Clyde Western Area Remediation Project, Stage 2 Audit Area 4

Site Audit Report No. 081-2127799

Viva Energy Australia Pty Ltd

14 June 2024

DRAWING No: C013919.06-CC35 | ISSUE: C

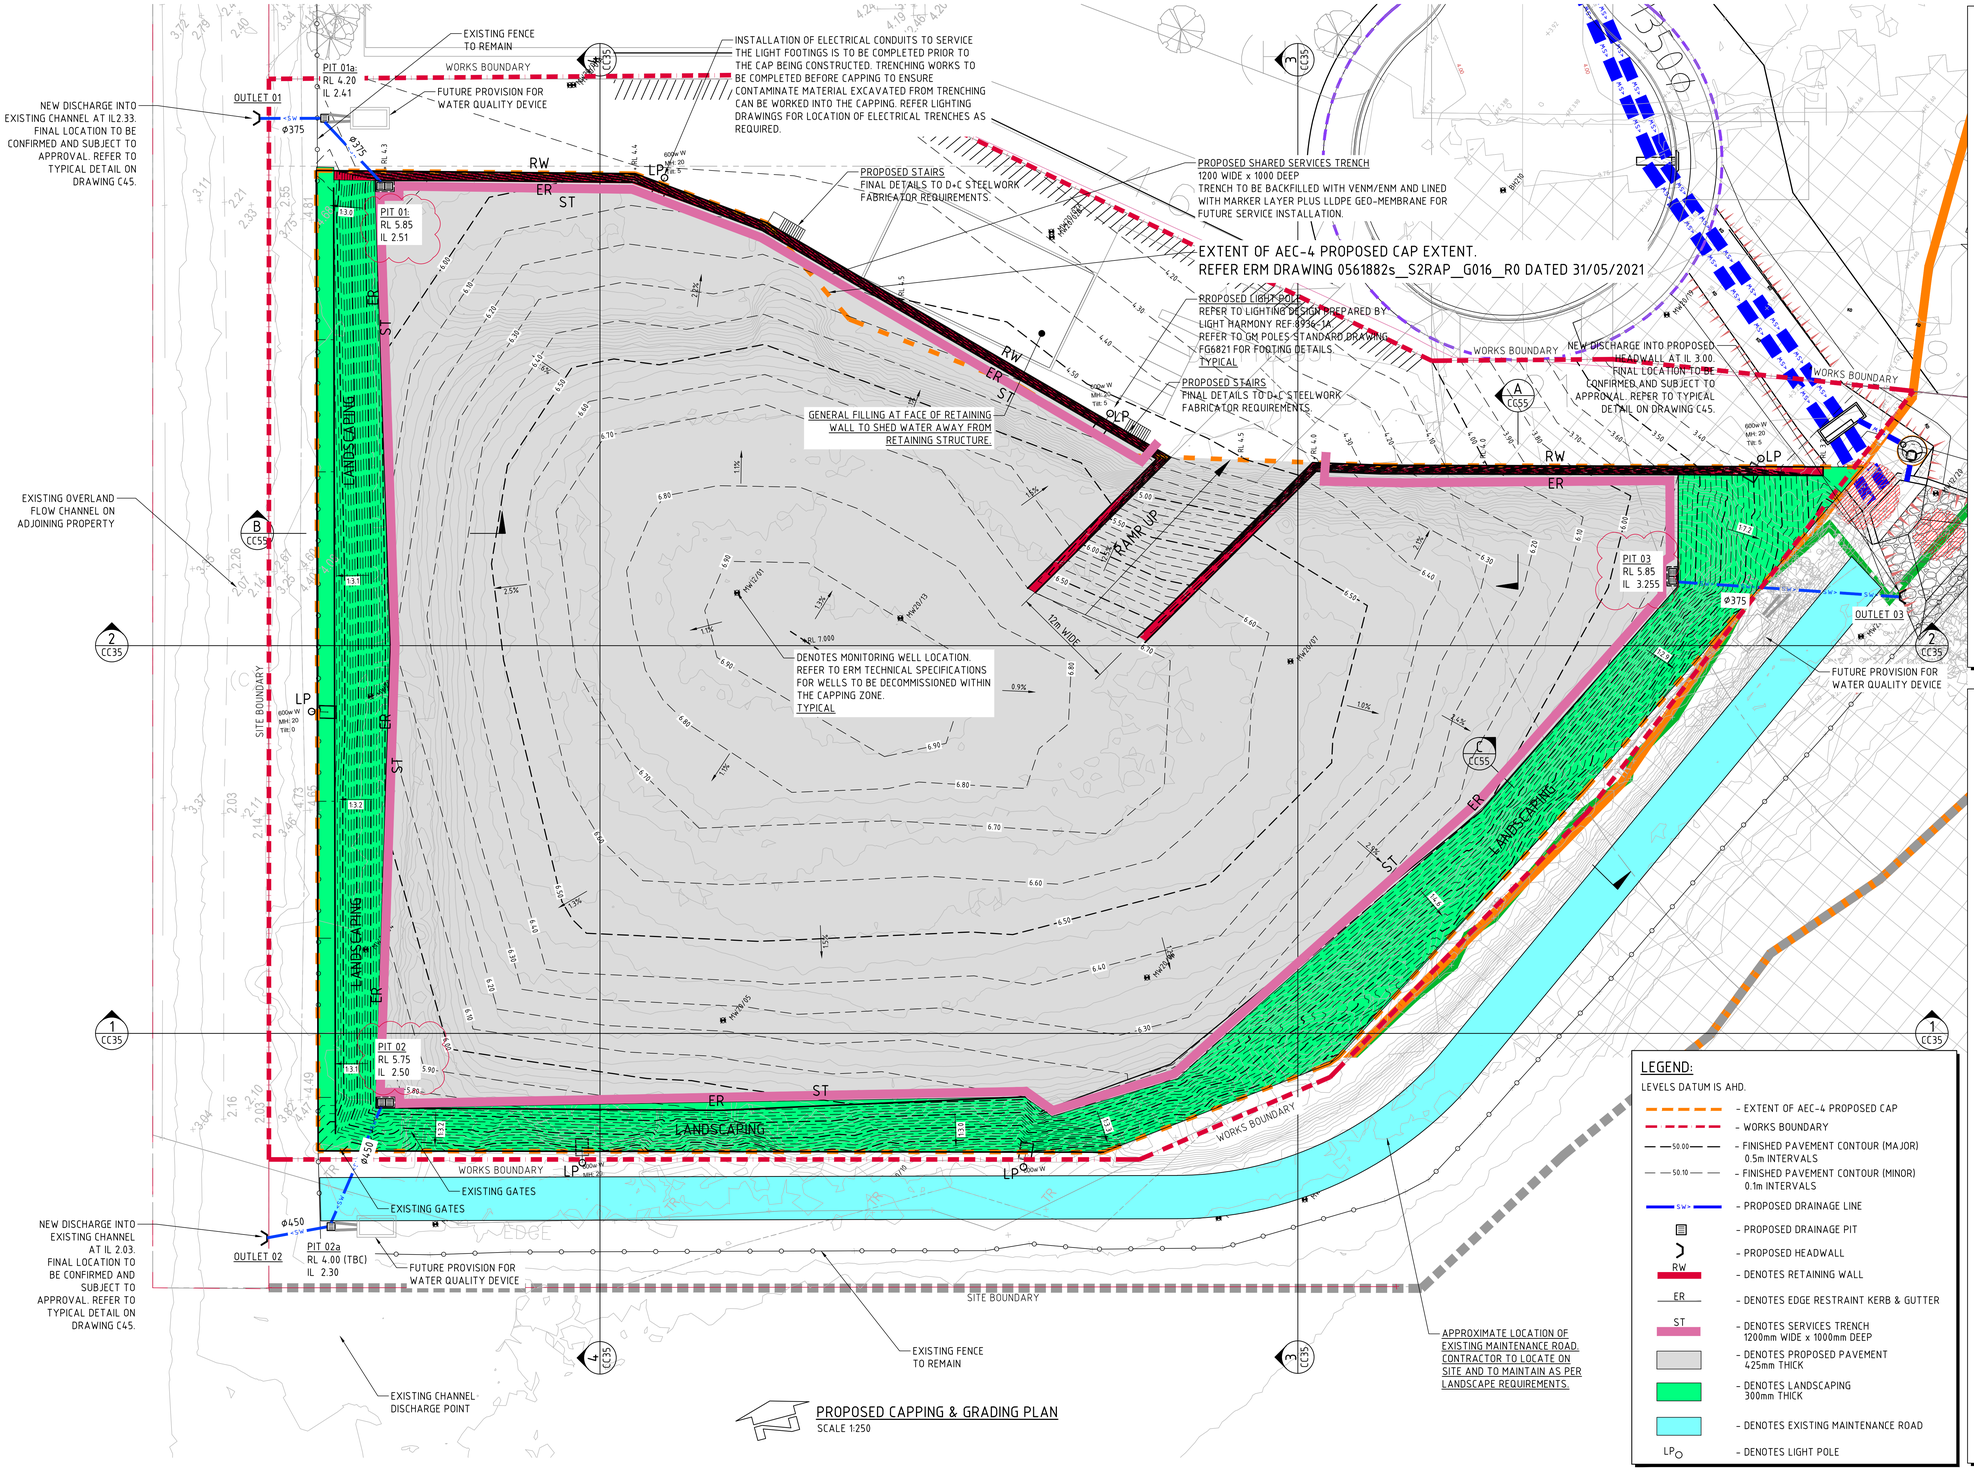
8	Drawing CO 13919.06 – C13.A	On C13, stormwater storm event sizing is missing (note 2).	CRC 17/06/2022: Refer to revised drawing C13. In-ground piped system has been designed for 20yr ARI or 5% AEP.			Comment closed.
9	Drawing CO 13919.06 – C14.A	C14 note 7 has instructions on moisture etc for site won fill. Is this appropriate for the contaminated soils?	Site won fill will require confirmation from ERM as validation consultant of suitability for re-use in accordance with the RAP, if placed above the marker layer. Technical specification for the works will provide key definition of material which will be suitable for placement above and below the liner/marker layer.	Noted.	-	Comment closed.

DRAWING TITLE: TYPICAL DETAILS SHEET 1
DRAWING No: C013919.06-CC55
ISSUE: E

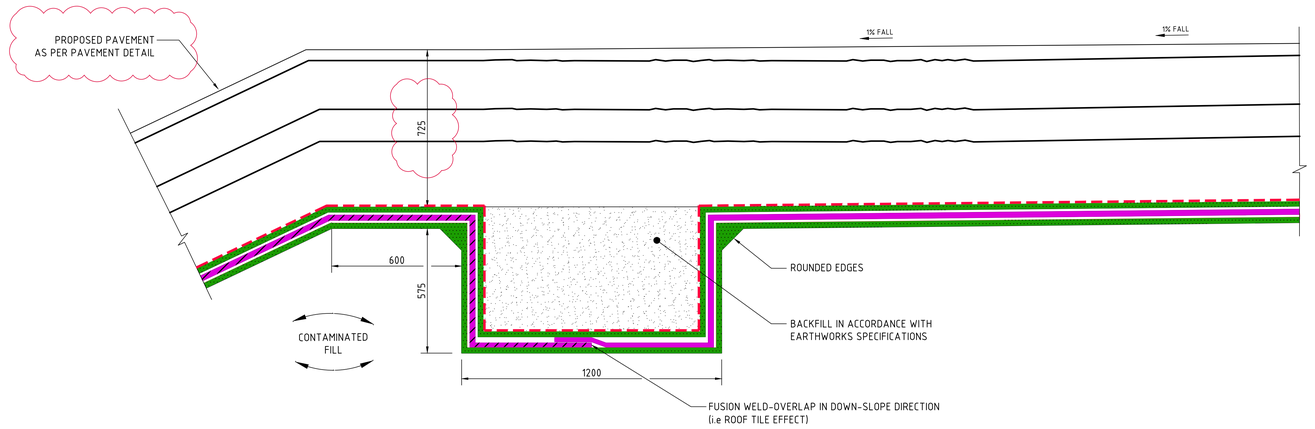
2	Drawing C10-C17.B	The cap is to limit water infiltration. Based on the HHRA, there is a potential for vapour intrusion risks for future commercial workers from impacted soils (refer to summary included in Section 2). Could there be gas/vapour build-up beneath the cap? Will subsequent vapour intrusion monitoring be required or should appropriate vapour mitigation measures be incorporated into the design?	ERM conducted a baseline ground gas monitoring event to address this query (Attachment B) On the basis of the information presented, the following is concluded in relation to the Site Auditor's query: - It is acknowledged that the installation of an impermeable geomembrane has potential to increase the lateral migration of gas generated from uncontrolled fill within the mound. However, evidence of recordable lateral gas migration to monitoring wells outside of the proposed cap extent has not been observed during the August 2022 gas monitoring event, despite the widespread coverage of the AEC-4 buried waste mound in hardstand for greater than 25 years. The proposed capped area also has no known service trenches which may act as a preferential pathway for lateral gas migration from the AEC-4 buried waste mound to adjacent areas within or outside of the proposed Lot 64 boundary into the future. - Additional gas mitigation measures, including installation of gas collection trenches and/or venting within the design for the AEC-4 cap are not considered necessary due to the characterised risk profile of the Site. The land use restrictions under a legally enforceabled LTEMP will effectively limit future human health exposure to hazardous ground gases (and petroleum hydrocarbon derived vapours) by limiting the construction of enclosed spaces or service trenches below the geomembrane. Furthermore, unsealed areas which cannot be redeveloped within the riparian corridor (as defined under SSD 10549) will border the proposed capped area to the west, south and east and provide opportunity for passive diffusion of gases in the unlikely event that gas accumulation and increased lateral migration from beneath the capped area did occur in the future.	Refer to Construction Tech Spec report comments.	Refer to tech spec report responses.	Refer to the auditor's comments presented in the Tec Spec review.

3	Drawing C10-C17.B	GCL will act as a marker layer to reduce exposure to asbestos contamination. Is the depth/type of material above the GCL sufficient for asbestos? (i.e. only 300 mm soil on the batters and will there need to be inspections/maintenance of these areas?).	Use of a LLDPE geomembrane has replaced GCL as a preferred option for liner. Use of a bright coloured geotextile marker layer has been incorporated above the liner, associated protection layers and underlying contaminated soil material to provide advance warning prior to penetration of these layers. This protection detail is provided on revised drawing C17. Battered slopes in revised design limited to eastern landscaped batter and incorporates erosion controls (geoweb/ planting of shallow rooted grasses (tubestock)/ overlain by jute mating of a minimum thickness of 300mm. With incorporation of these engineered erosion controls it is not considered that inspections or maintenance will be required to confirm 300mm cover is maintained.	Noted.	-	Comment closed.

4	Drawing C10-C17.B	Will there be any specification for the materials to be placed directly against the GCL (above and below)? e.g. maximum particle size, cation exchange capacity. Does there need to be a minimum soil layer between the contaminated fill and the GCL?	The revised detailed design specifies the use of a non-woven, heavyweight geotextile layer above and below the LLDPE liner, or the use of a 100mm sand protection layer (subject to constructability requirements determined by the Contractor). Particle size of <19mm, free of sharp or angular objects which may damage the geomembrane have been nominated within the technical specification as suitable material properties for this purpose.	Noted.	-	Comment closed.
5	Drawing C10-C17.B	The GCL is shown to pass under stormwater pipes, under roads and pavements, and behind retaining walls. It is not shown specifically to be continuous under the stormwater pits.	The geomembrane will be continuous under the stormwater pits, refer to revised detail on drawing C17.	Noted.	-	Comment closed.

6	Drawing C10-C17.B	Any water that migrates through the pavement or vegetation soil should be able to drain out, so it does not pond on the GCL. Any areas of ponded water will have higher infiltration. In particular, the anchor trench at the batter toe and at the edge of the pavement where the concrete kerb is proposed are areas where water may not be able to drain. The cross-sections also show some existing bunds around the perimeter of the works which may prevent water from draining from the capped area.	CRC 17/06/2022: The capped area has been designed with a >1% slope towards the provided drainage pits, consistent with surface grading. Any water ingress through the pavement and on top of the geomembrane will be directed towards the drainage pits and captured by the drainage trench.	Noted.	-	Comment closed.
7	Drawing CO 13919.06 – C13.A	On C13, northeast corner, near Pit 03 discharge it looks like the works interact with a large headwall.	Revised design incorporates three separate stormwater drainage outlets (Drawing C13). Design for outlets, including dissipation is shown on new Drawing C18. Separate outlets to the original headwall have been proposed as these are not reliant on the construction of the roadway and associated drainage and headwall (by others) prior to capping construction	Revised drawing C13 – Proposed shared services trench. "lined with marker layer plus GCL". Should this be geomembrane?	-	Yes, the auditor was referring to the geomembrane. Comment closed.
